TO: Mercedes-Benz Dealer Principals, General Managers, Sales Managers, Service Managers, Parts Managers	FROM: Gregory Gunther, Senior Manager, Vehicle Compliance and Analysis, Engineering Services
RE: Recall Campaign Initial Notification Check the Driver and Front Passenger Seat Rail Bolts (254)	DATE: November 22, 2024

Campaign No. 2024110003, November 2024

SUBJECT: **Model GLC (254 platform)**
Model Year 2023

Check the Driver and Front Passenger Seat Rail Bolts

Figure 1

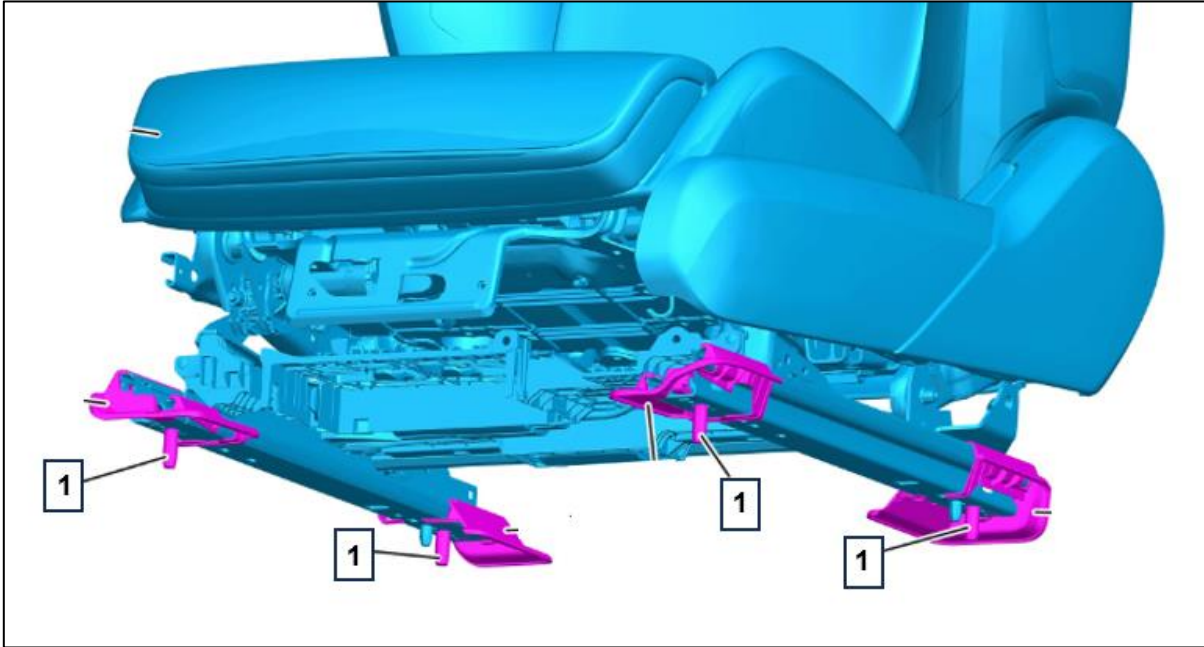
1. Check to see if mounting bolts (**Figure 1, 1**) are present on the front passenger and driver seat rails.

- a. If **all bolts are present** on both front seats:
Loosen and retorque bolts (Figure 1, 1) on both front seats to specified tightening torque (50 Nm).
i For basic information, see AR91.10-P-1000WT and BA91.10-P-1001-01T.
- b. If **bolts are not all present** on both front seats:
Retrofit bolts on front seats that are missing and retorque all bolts to specified tightening torque (50 Nm).
i For basic information, see AR91.10-P-1000WT and BA91.10-P-1001-01T.
